66101A-09A

S E R V I C E N O T E

66101A DC Power Supply

The instrument will not communicate or will not complete self test.

Figure 1

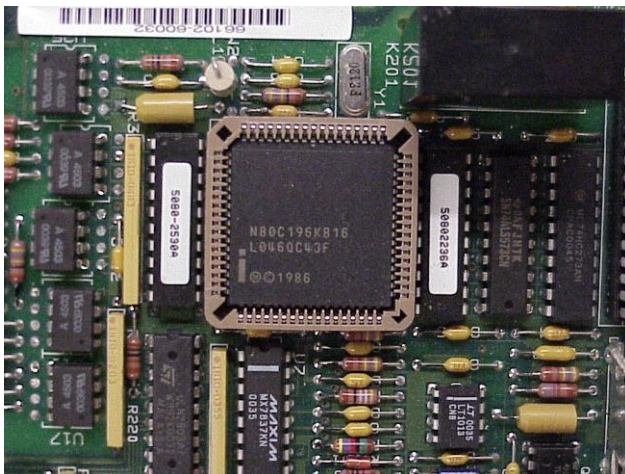
Figure 1 will help to identify the **68-PIN PLCC SOCKET location - P/N 1200-1274** (Circuit Reference “U001”)

Any Model having a serial number starting and ending with the serial numbers shown in the chart below should have the socket 68-PIN PLCC SOCKET - P/N 1200-1274 (Circuit Reference "U001") **REPLACED!**

Figure 2

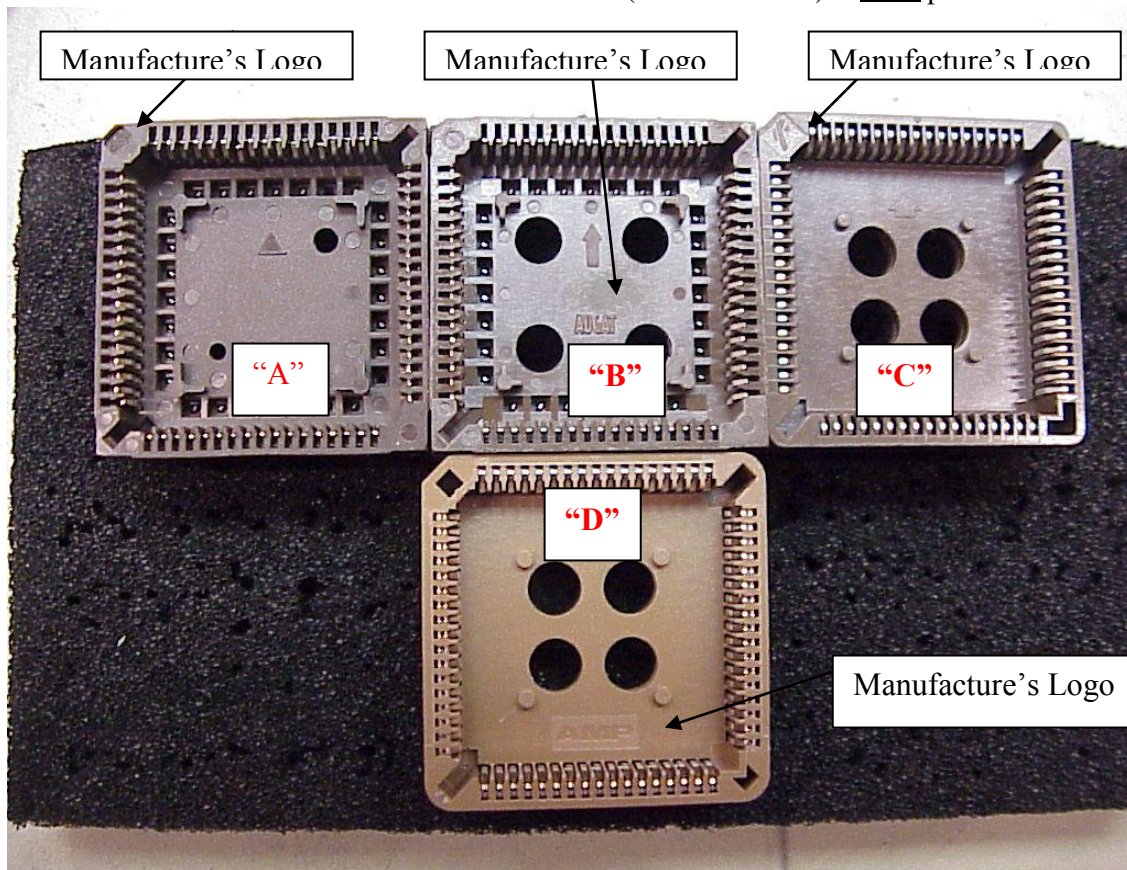
This figure should be used to identify **GOOD** sockets and a potential defective socket. The **16-Bit MCU 16 MHZ 68PLCC CMOS IC (P/N 1821-1479)** is **NOT** pictured.

- Socket **"A"** is a sample of a GOOD AMP socket.
- Socket **"B"** is a sample of a GOOD Tyco/Augit socket.
- Socket **"C"** is a sample of a GOOD FCI socket.
- Socket **"D"** is a sample of a DEFECTIVE Tyco socket.

The sockets above labeled **"A", "B" or "C"** are good and should NOT be replaced.
The socket above labeled **"D"** is considered defective should be replaced.

Discipline B – Verification of Corrective Action “The socket shown in the pictures are for reference ONLY”

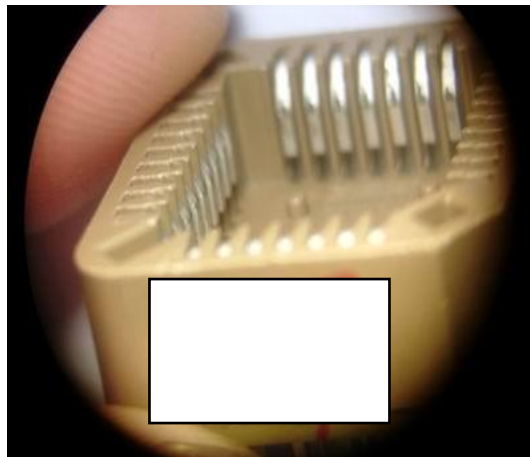
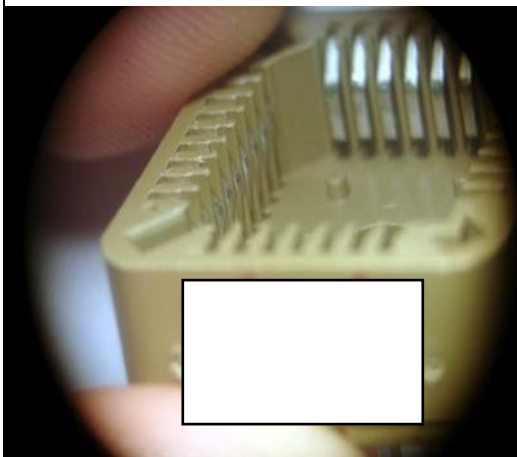
The condition of the recessed beams has been corrected by a design enhancement implemented in production. This design enhancement increased the spring height dimension by 0.04mm and decreased the spring height tolerance by 40%. The spring height dimension is shown in the drawing below.

The effectiveness of this design enhancement was tested by comparing the mating and un-mating forces on the older and newer designs. The test results for sockets with the increased spring height (newer design) showed an increase in the mean mating force of 18.9% and an increase in the mean un-mating force of 23.4%. The increase in the un-mating force test results between the old design and the new design indicate that a greater normal force is being exerted on the test chip contacts by the socket contact beams. The two revisions of this contact beam design were visually examined after the mating and un-mating force testing. Photos of the two sockets are shown below. The photo on the left shows the older version socket prior to the enhanced contact beam design. The photo on the right shows a socket with the design enhancement. The contacts with the older design appear to be recessed farther into the housing after un-mating.

Material with this design enhancement will be labeled with a 2007 date code
